ENGINEER'S CERTIFICATION NOTES

GOLDEN VENTURES
DETAILS AND PROFILES

GOLDEN VENTURES
GRADING AND DRAINAGE PLAN

**KARSTEN EXPANSION
GRADING AND DRAINAGE PLAN**

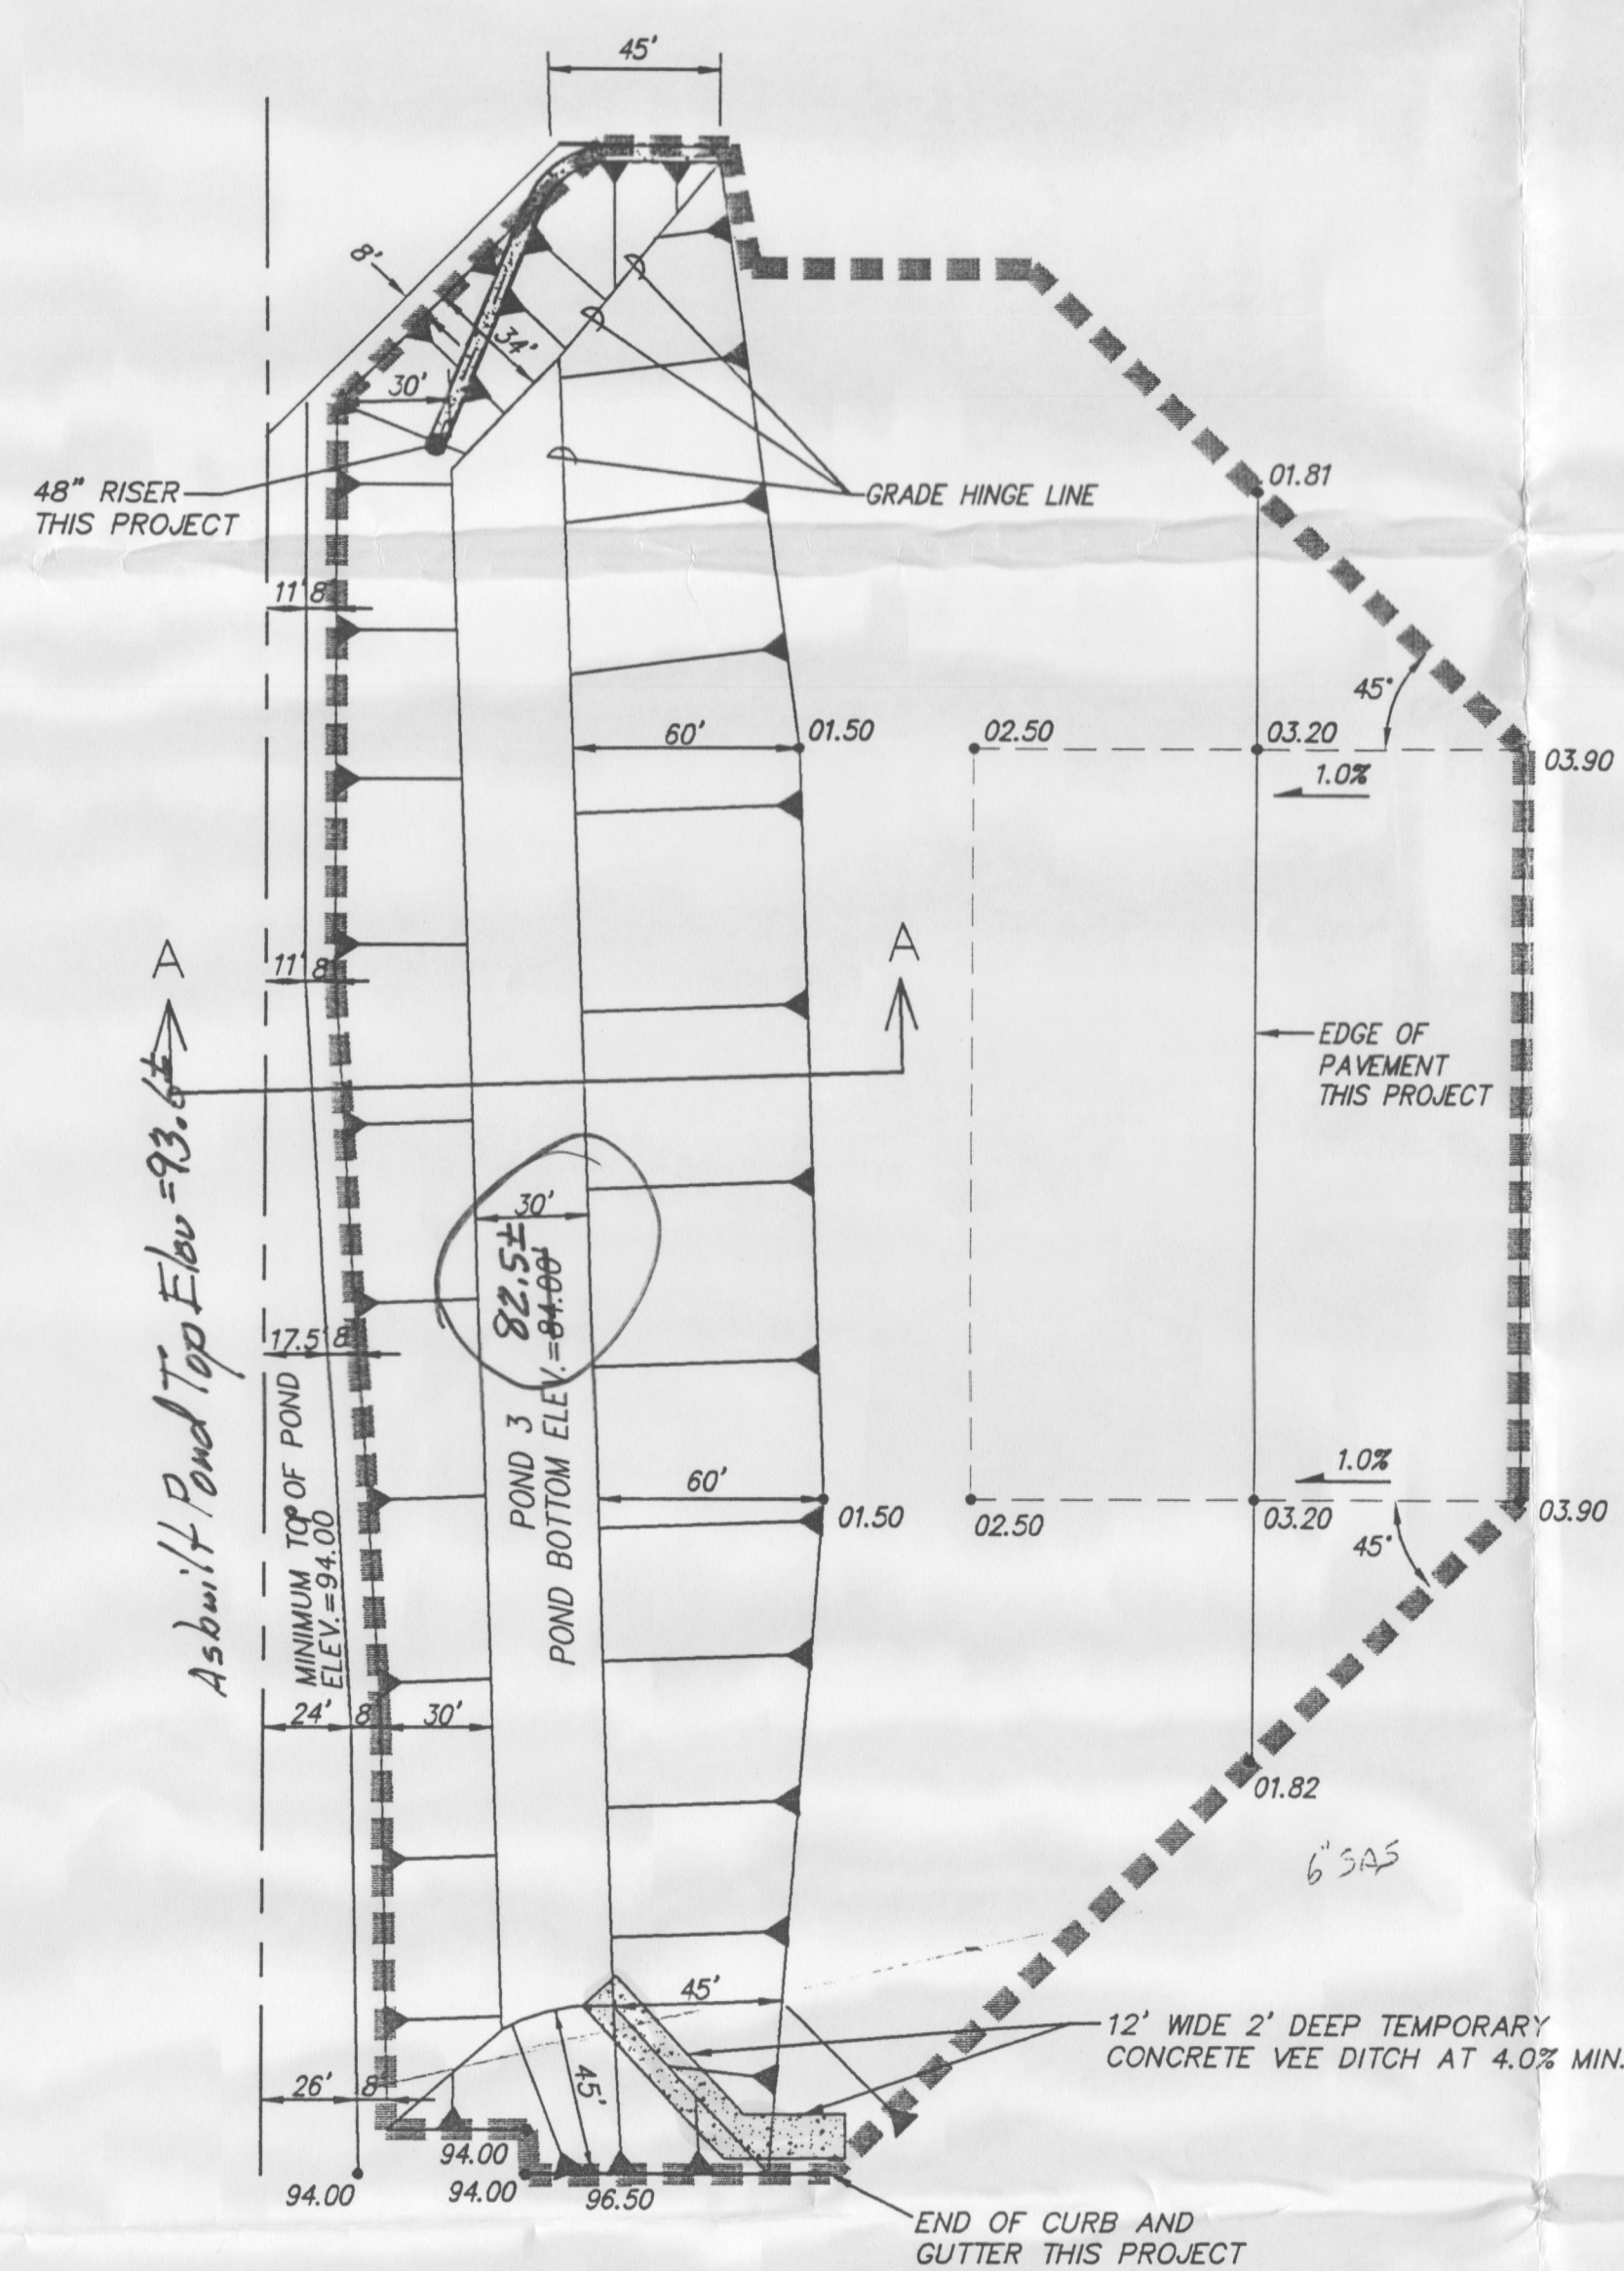
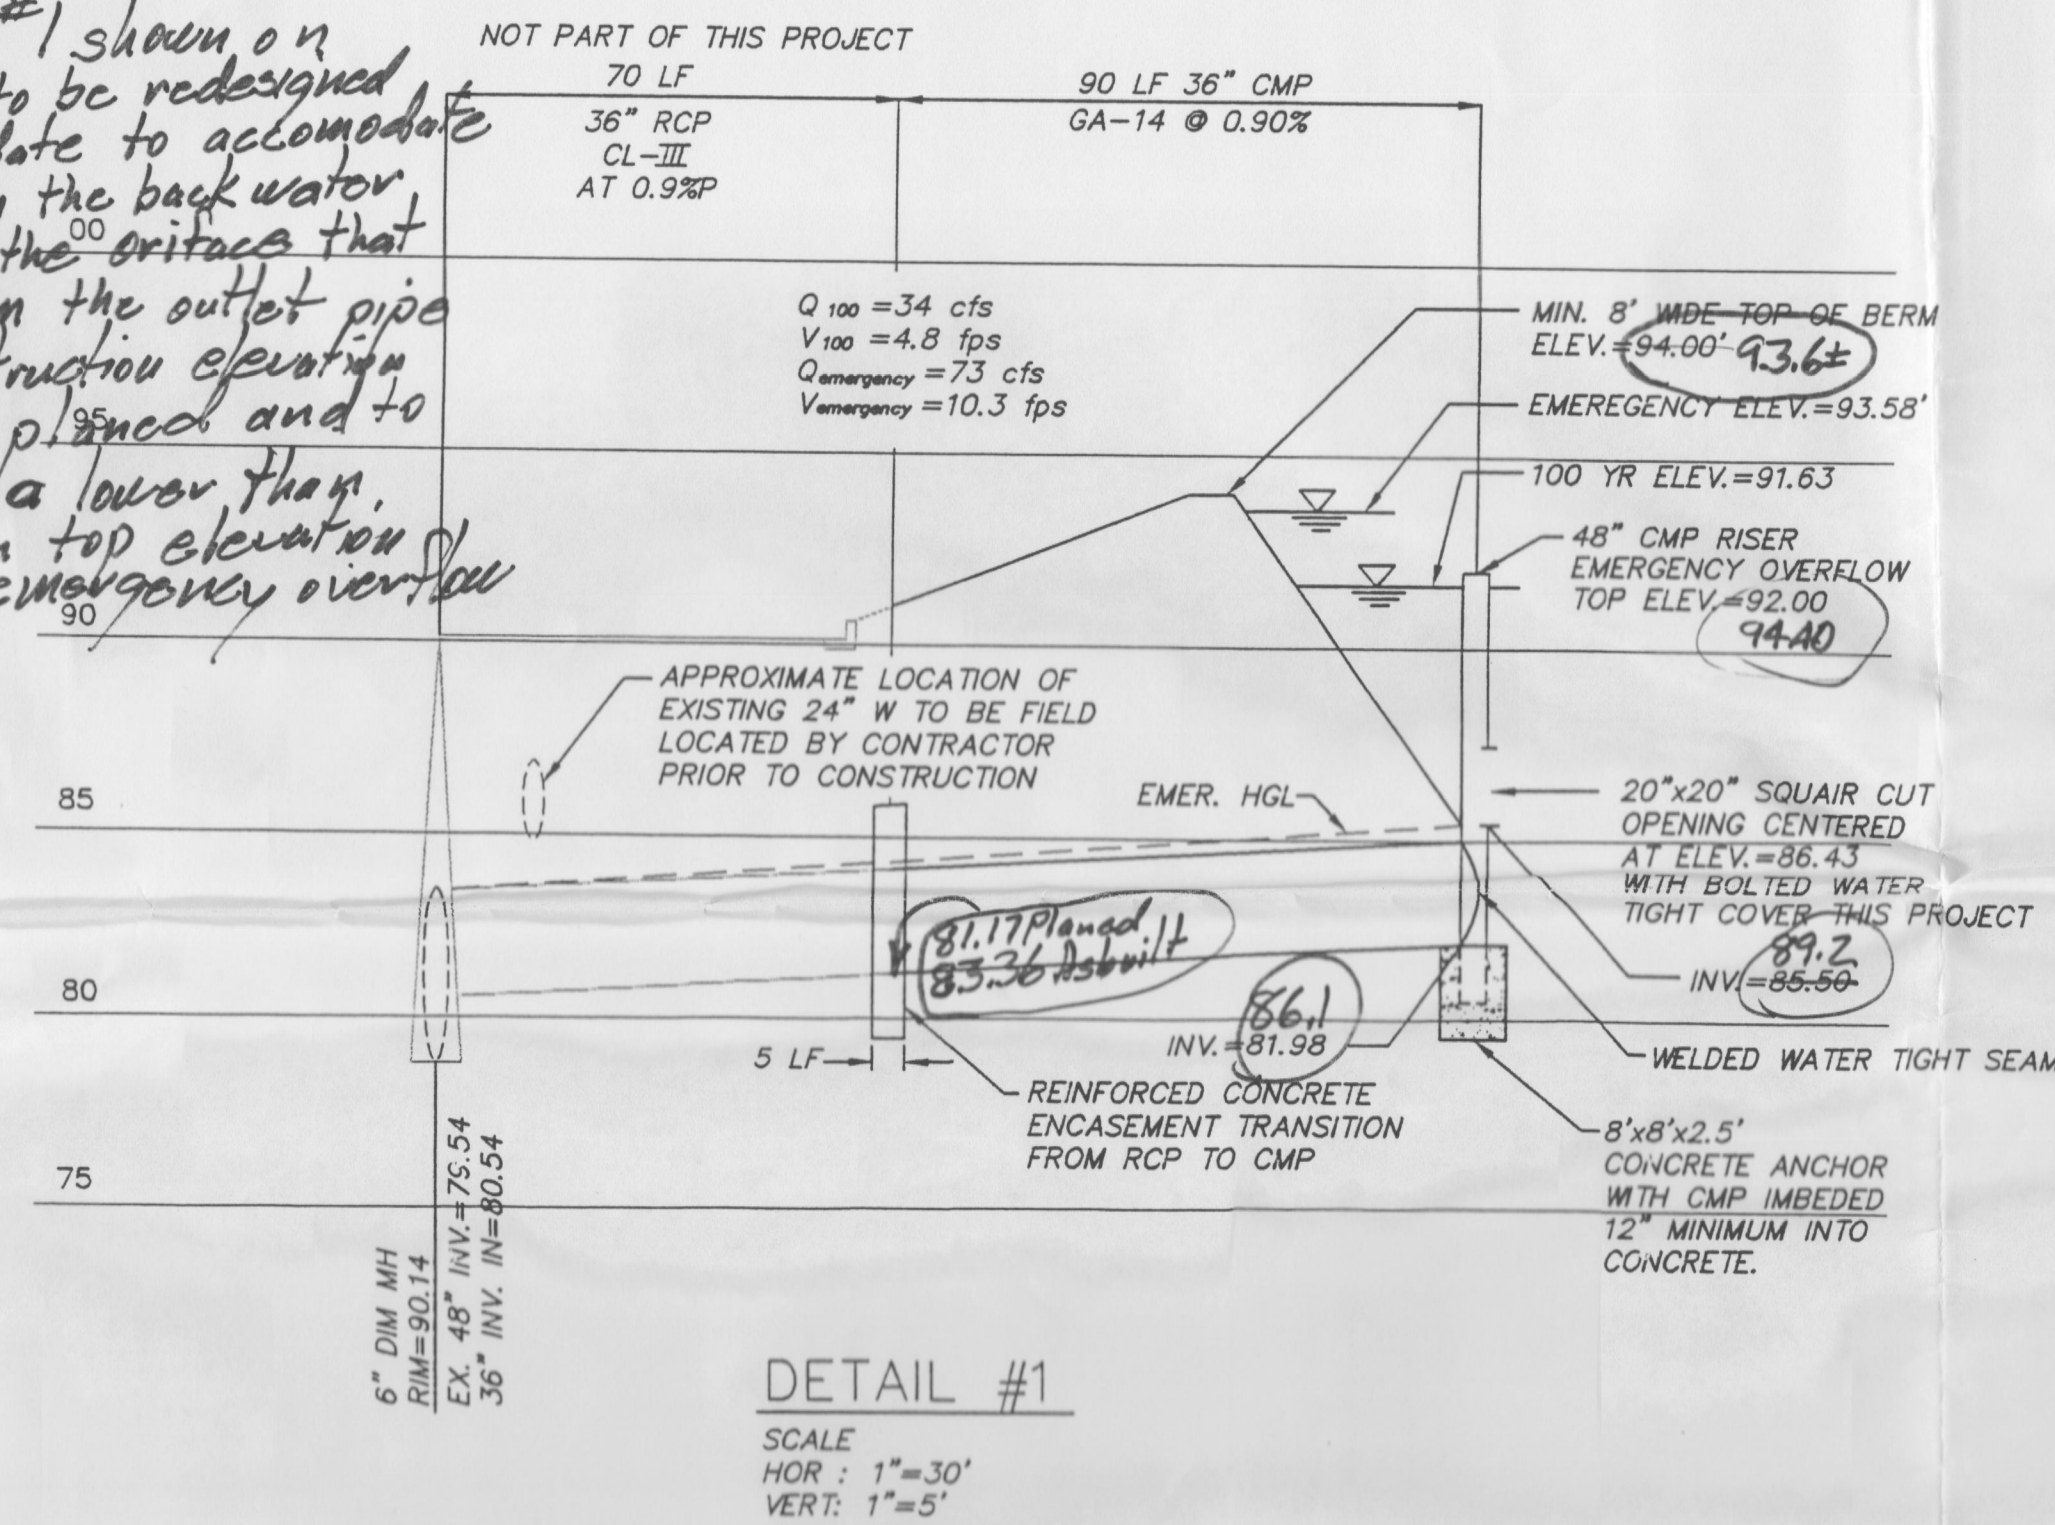
Asbuilt Note:
Future pond #1 shown on
Sheet #1 is to be redesigned
at a later date to accommodate
the change in the back water
pressure on the outlet that
resulted from the outlet pipe
As built Construction elevation
higher than planned and to
decommission a lower than
planned dam top elevation
and lower emergency overflow
Weir.

GRADING AND DRAINAGE PLAN

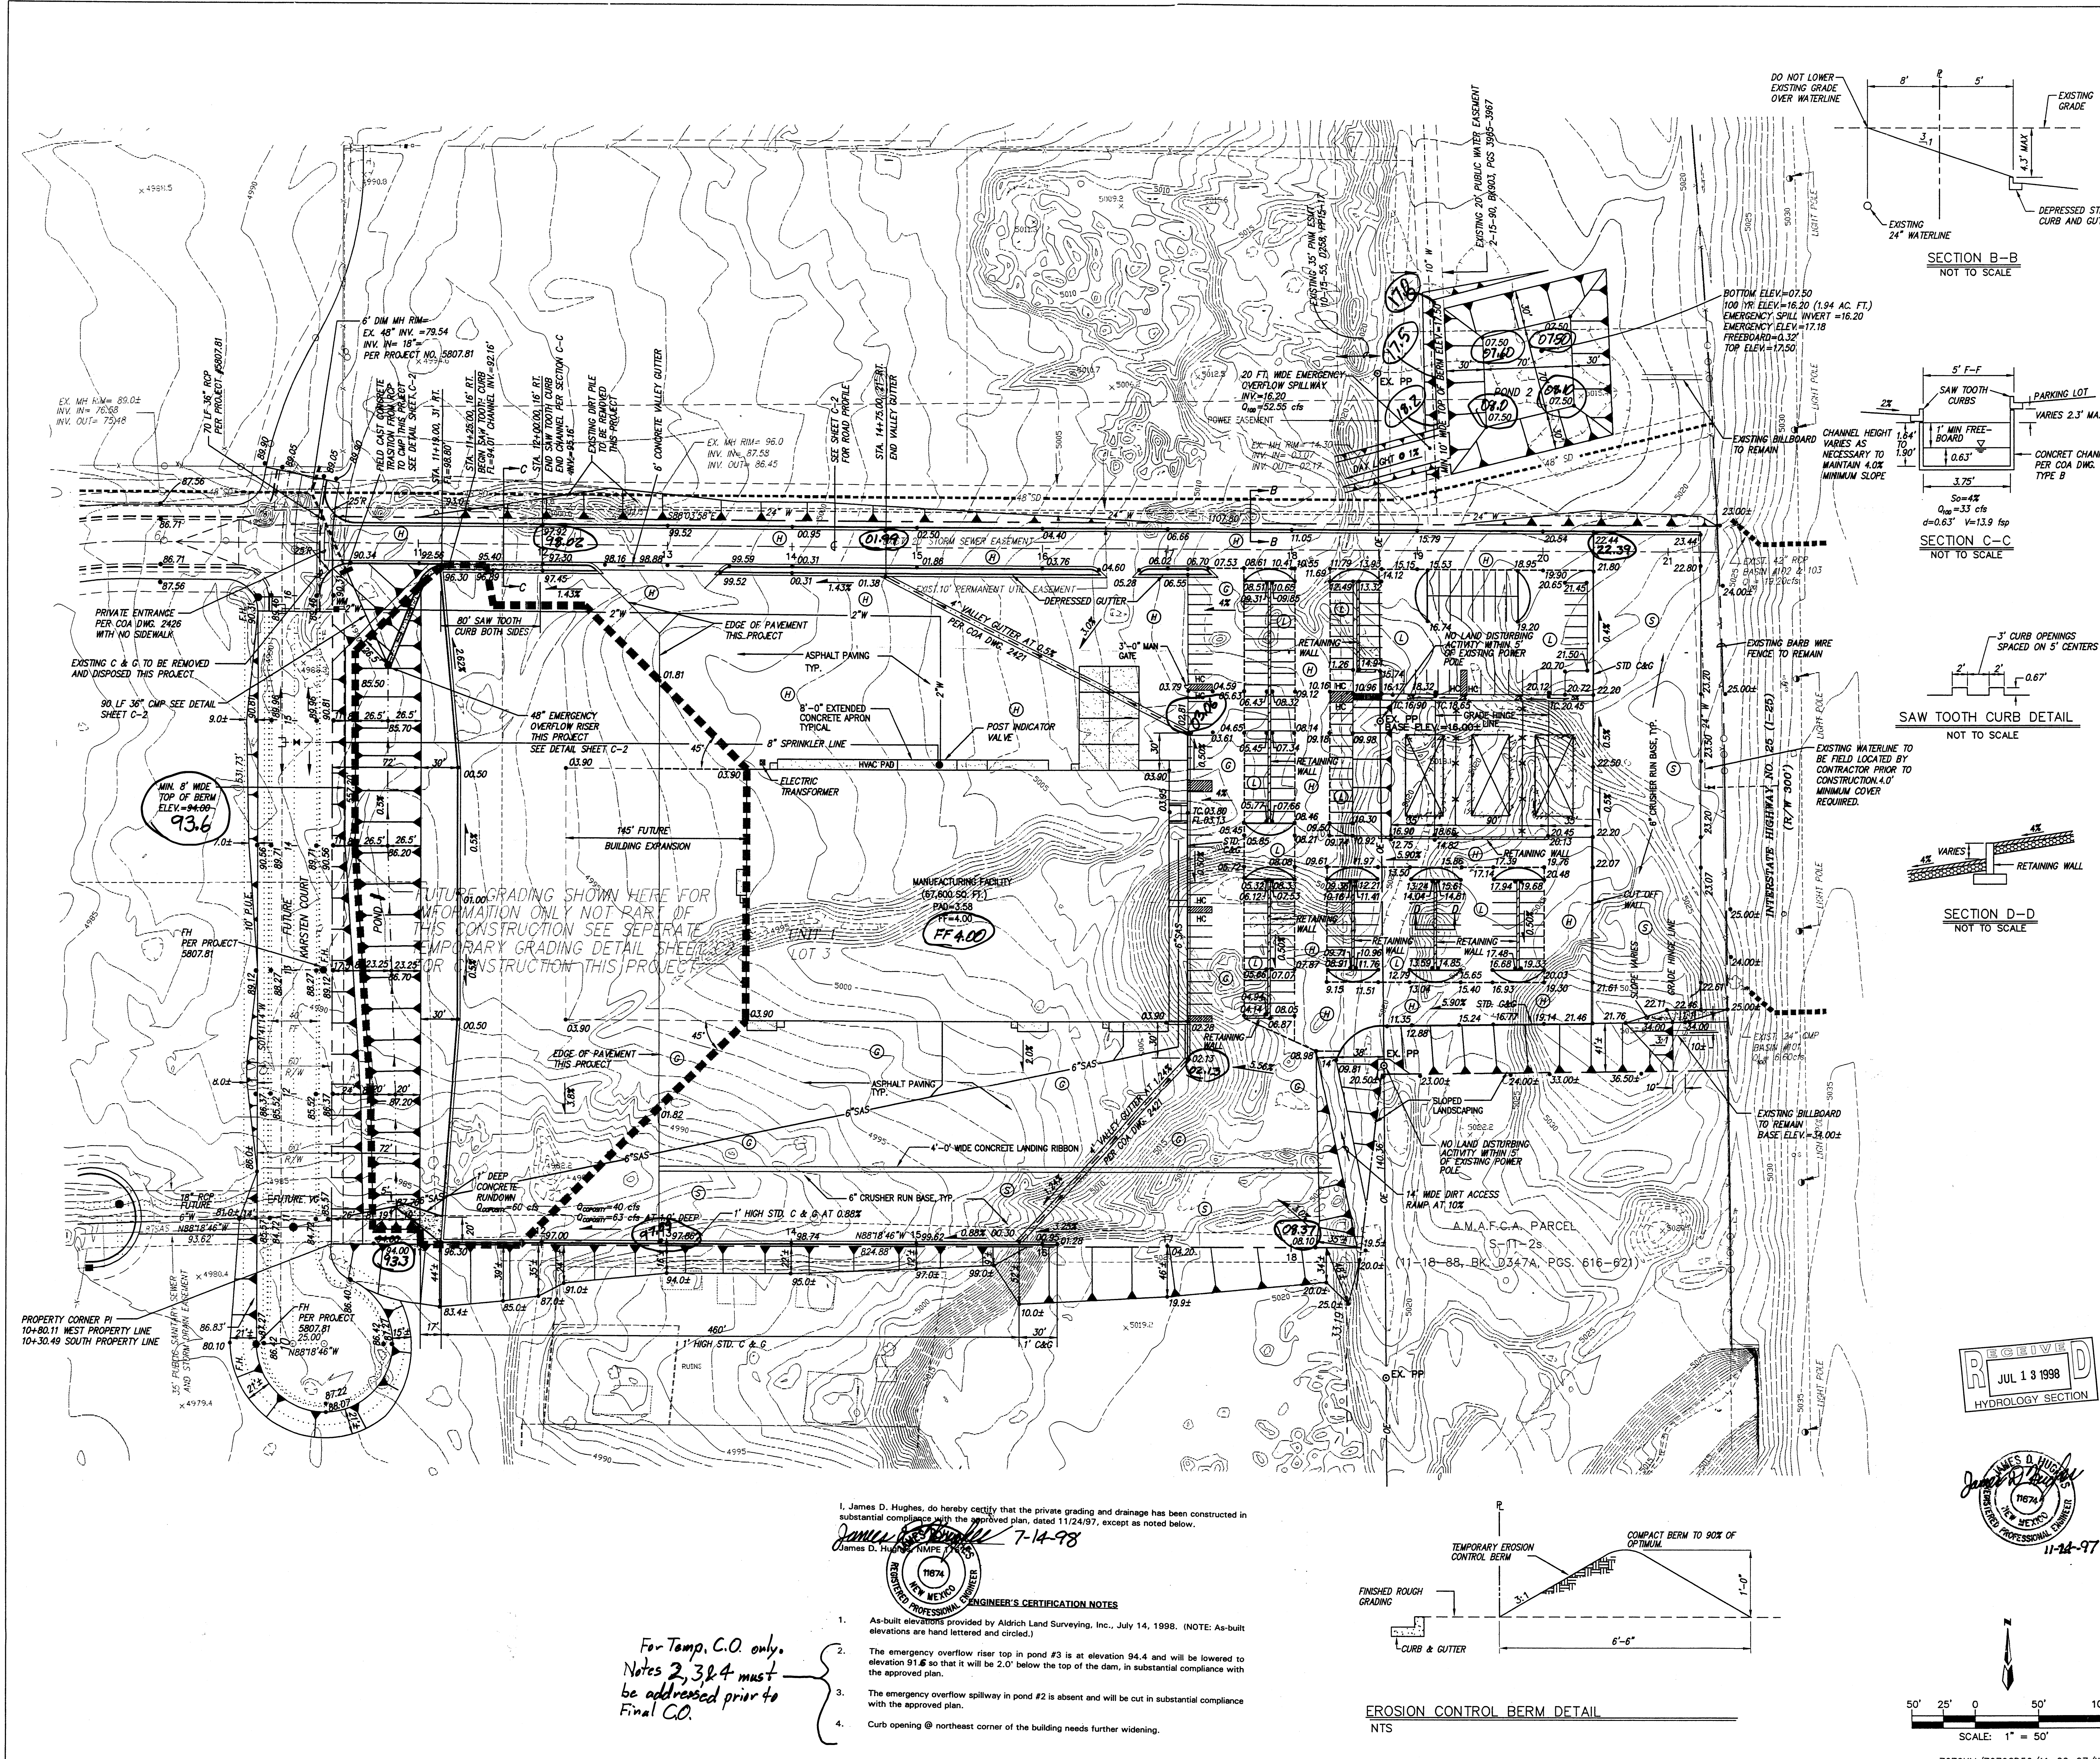
- As-built elevations provided by Aldrich Land Surveying, Inc., July 14, 1998. (NOTE: As-built elevations are hand lettered and circled.)
- The emergency overflow riser top in pond #3 is at elevation 94.4 and will be lowered to elevation 91.6 so that it will be 2.0' below the top of the dam, in substantial compliance with the approved plan.
- The emergency overflow spillway in pond #2 is absent and will be cut in substantial compliance with the approved plan.
- Curb opening @ northeast corner of the building needs further widening.

For Temp. C.O. only.
Notes 2, 3 & 4 must
be addressed prior to
Final C.O.
